RECEIPT DATE: 12/18/2021 **ONSITE SEWAGE DISPOSAL SYSTEM** P 570880

ONSITE SEWAGE DISPOSAL SYSTEM DESIGN PLAN

MAPLE VIEW LOT 2

SDP-20-067

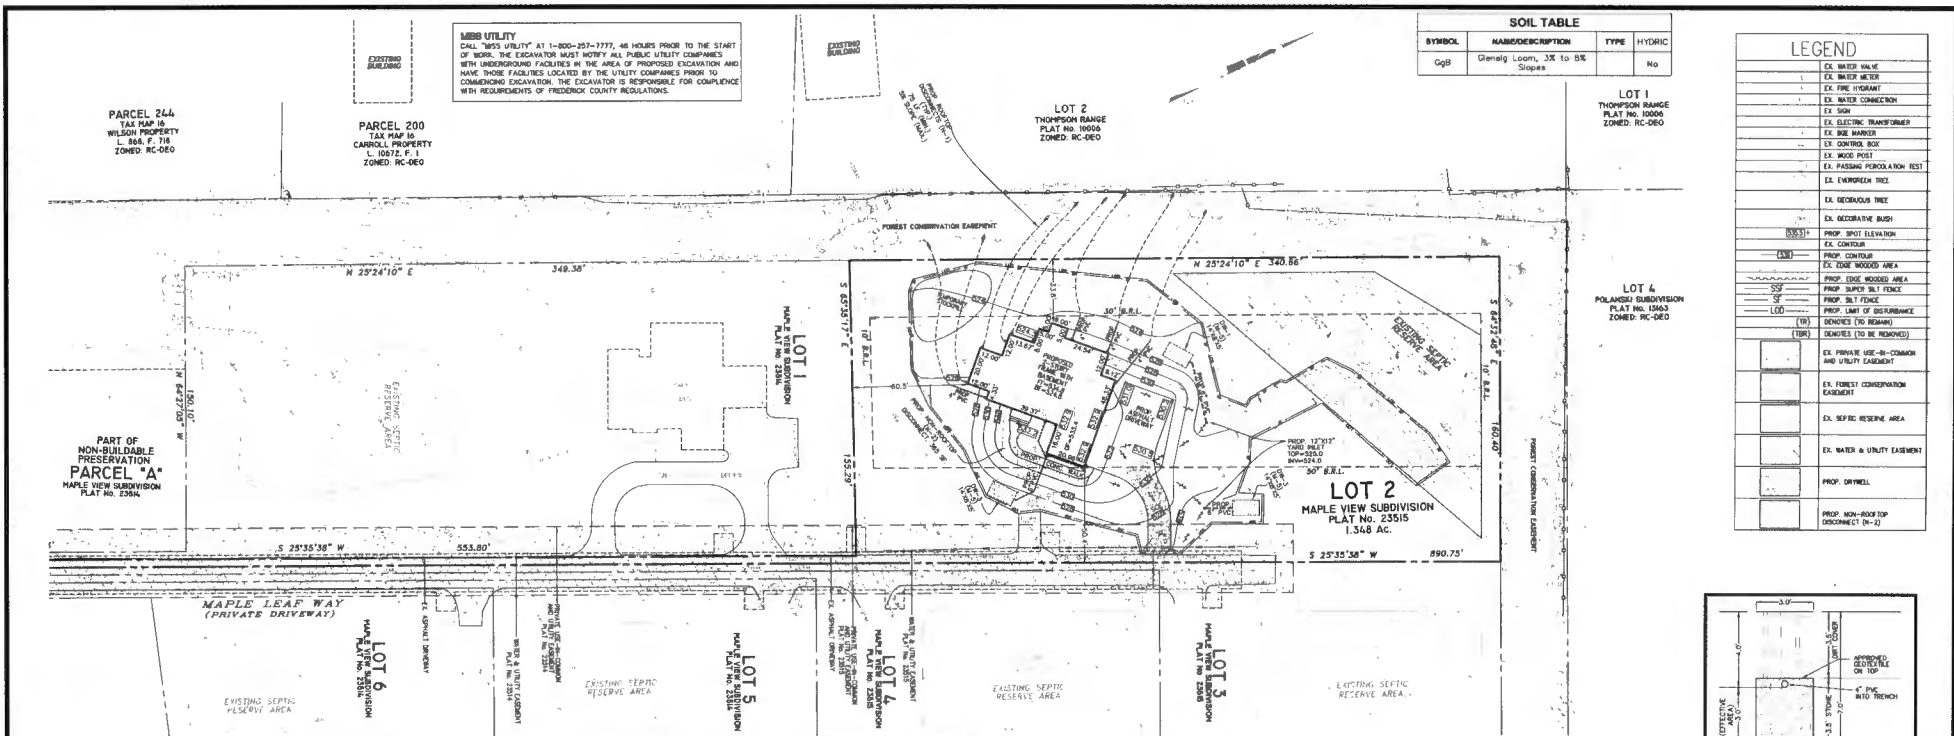
I have a couple of questions about SDP-20-067, Maple View Lot 2. What type of pond are you showing on the plan? Is it a rain garden? Is a wet pond with water in it all of the time? What is the distance between the SDA and storm water discharge pipe?

1.) Change signature block to read public water or delete altogether and add note to plan that property is served by public water. Please note that we use a Health Department approval stamp on OSDS Plans, so a signature block isn't necessary.

2.) Adjust yard inlet to meet the 25 foot setback distance to the septic tank.

3.) Reduce gravel above trench invert to 2 inches per Howard County County Code 3.813 in Trench Detail on page 2.

Thanks for the clarification. Can you update the OSDS Plan and send in paper copies.

The Micro-Bio Retention facility is basically a rain garden with some extra filtration media and it will not hold water more than a few minutes after a rain event. The solid SCH-40, 4" PVC is only an Overflow pipe that will not carry water unless the facility is overwhelmed by a rain event. This pipe is shallow and the enter line is over 4' off of the edge of the SDA.

Yes, that's fine. 2 inches of gravel above the pipe in the trench is typical.
